Wake County Mini City EMS

Esse Architects Project #2506 | Owner ID: RFB #26-075

Addendum No. 1

September 2, 2026

A101
FLOOR PLAN

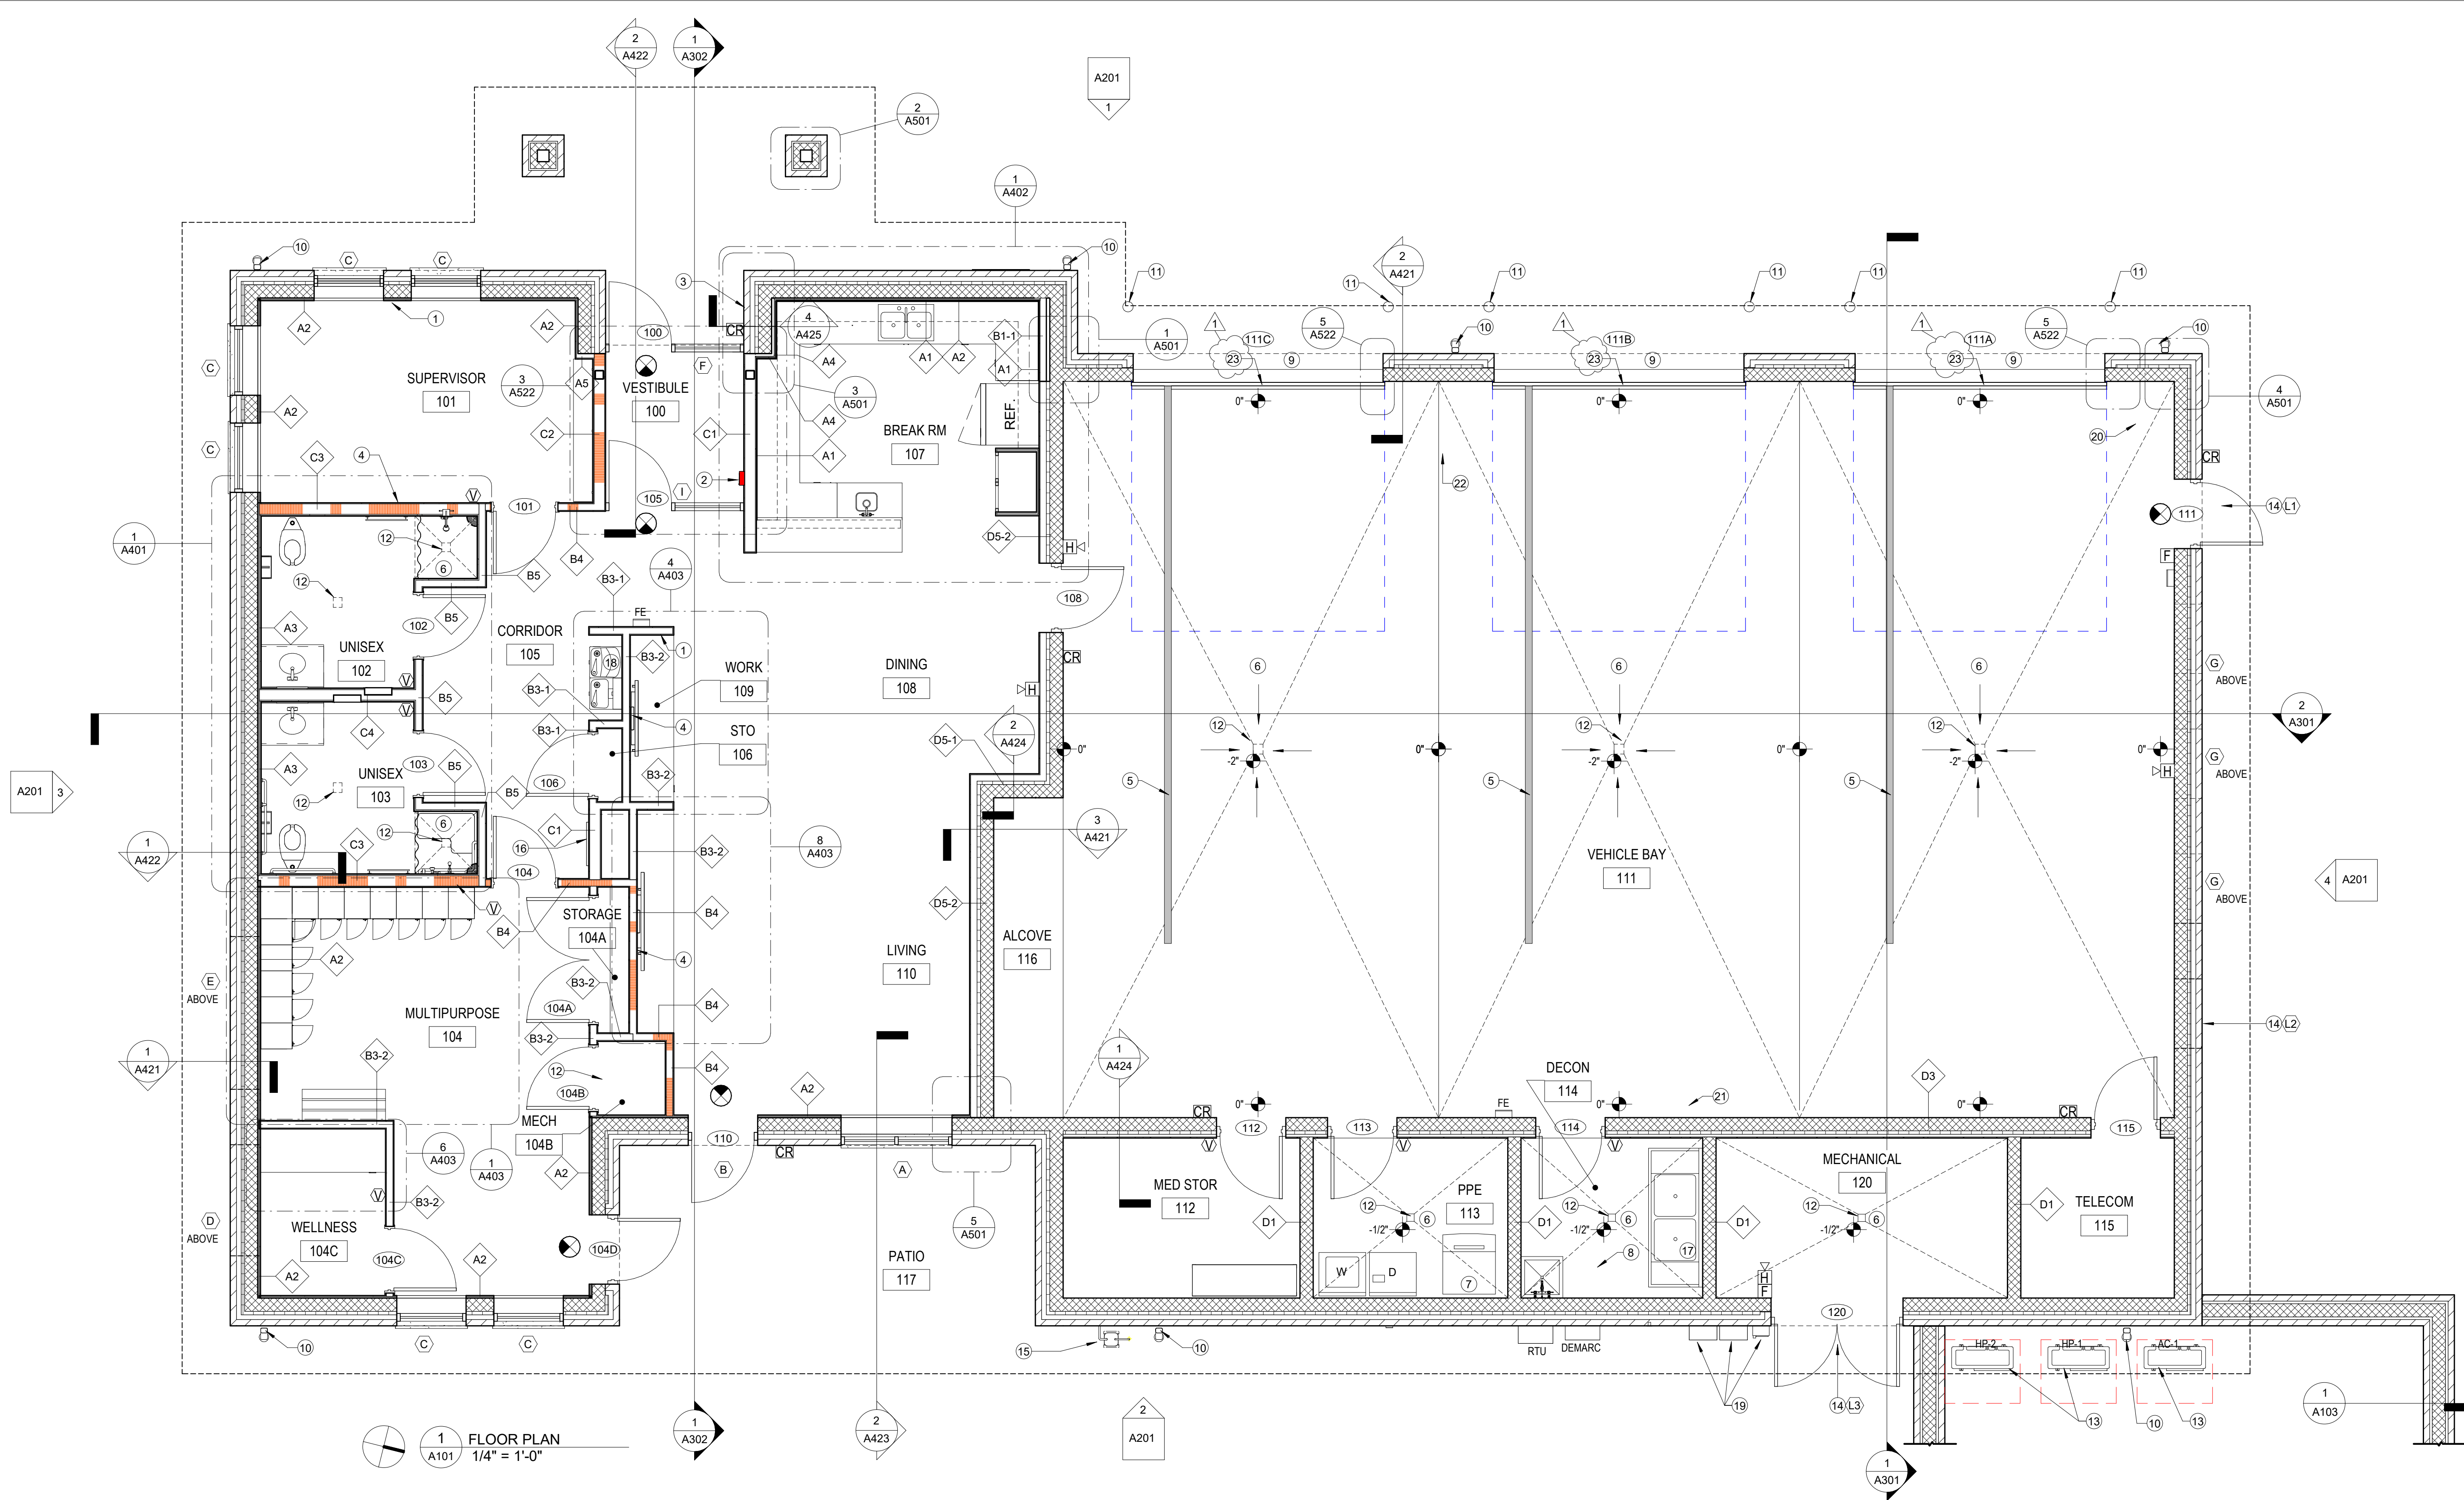
| 1. | Sheet A101 – Floor Plan – Make the following revisions: <ul style="list-style-type: none">a. At Doors 111A, 111B, and 111C add GENERAL KEY NOTE 23 to read “SECTIONAL DOOR CONTRACTOR MUST RESPOND TO SERVICE CALLS WITHIN 1-HOUR AND EMERGENCY WARRANTY ITEMS WITHIN 24-HOURS.” |

21	CONTROLS PANEL - SEE ELECTRICAL
22	GREASE TRAP - SEE PLUMBING DRAWINGS
23	SECTIONAL DOOR CONTRACTOR MUST RESPOND TO SERVICE CALLS WITHIN 1-HOUR AND EMERGENCY WARRANTY ITEMS WITHIN 24-HOURS.
